RE: ENGINEER CERTIFICATION FOR ORTH-MEDICS INCORPORATED (M16-D22)
CERTIFICATION STATEMENT DATED 12/9/92.

RE: DRAINAGE PLAN FOR ORTHO-MEDICS, INC.
(M-16/D22) ENGINEER'S STAMP DATED JANUARY 27, 1988

RE: Engineer's Certification for Ortho-Medics
Incorporated (M16-D22)

RE: ENGINEER'S CERTIFICATION FOR ORTHO-MEDICS INCORPORATED (M16-D22)
CERTIFICATION STATEMENT DATED 10/19/92.

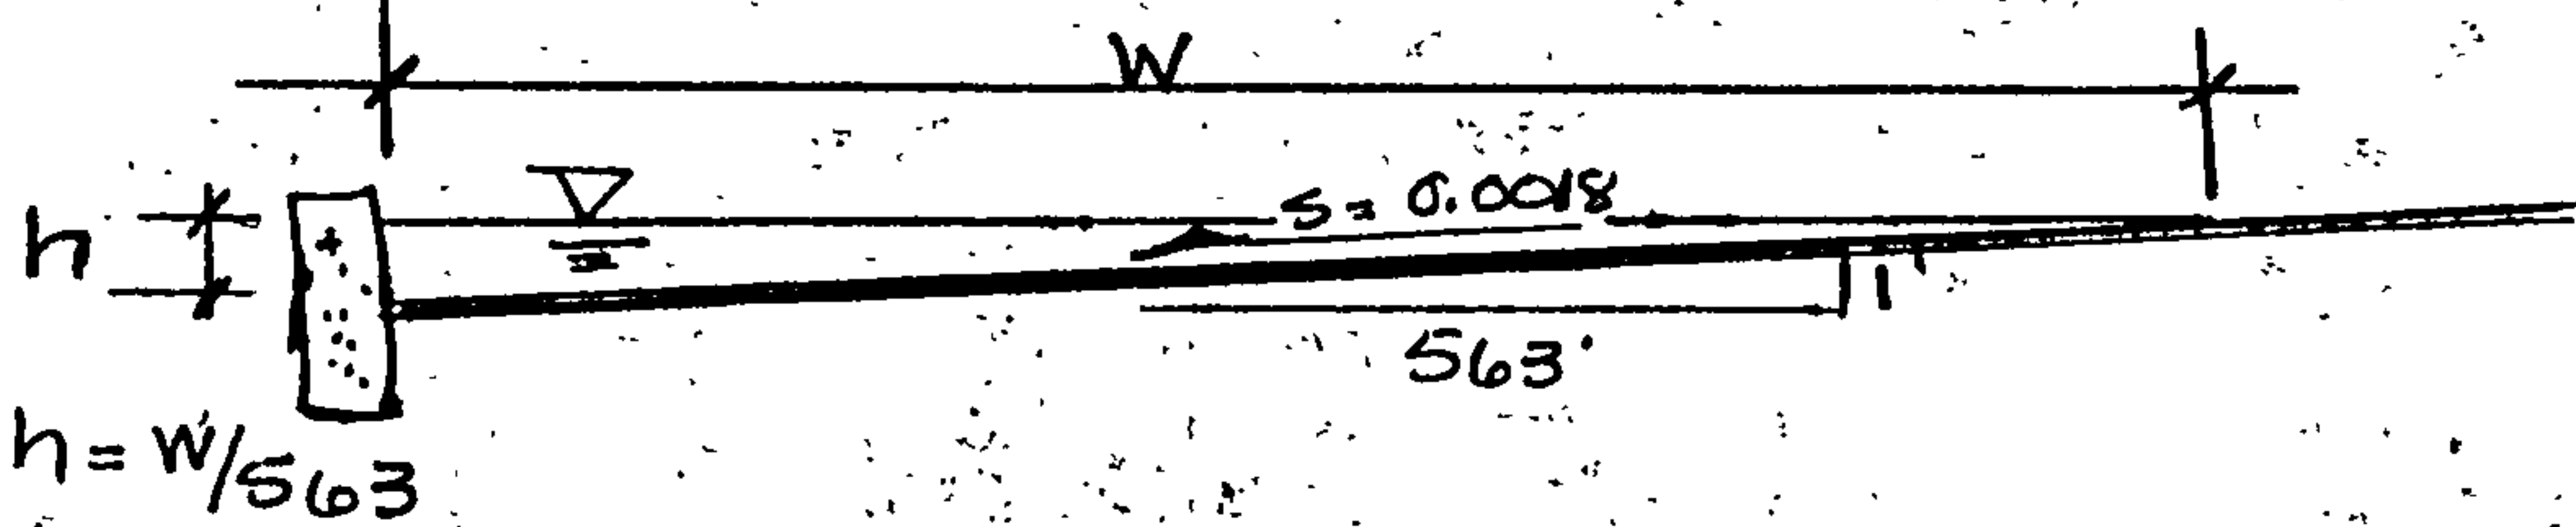
1. Proposed building and parking are no longer proposed, they are existing. Please identify as existing and include an as built finished floor elevation to full mean sea level.
2. There is a down spout on the west side of the building, that drains onto Tract A-6. Was permission obtained to route the roof run-off onto private property?
3. Portion of basin 1, south portion also drains onto basin 2, you may need to include a blanket drainage easement for the run-off from basin 1 onto basin 2 instead of just one easement.

1. We have corrected the plan to indicate the current existing conditions. The existing as built finished floor elevation has been added to the plan (mean sea level).
2. The down spout on the west side of the building that drains onto Tract A-6 has been re-routed to the south, along the building, to a dry well (see attached letter from Mr. Ron Bohannan).
3. A blanket drainage easement will be provided from the proposed west lot to the proposed east lot on the replat for this property.
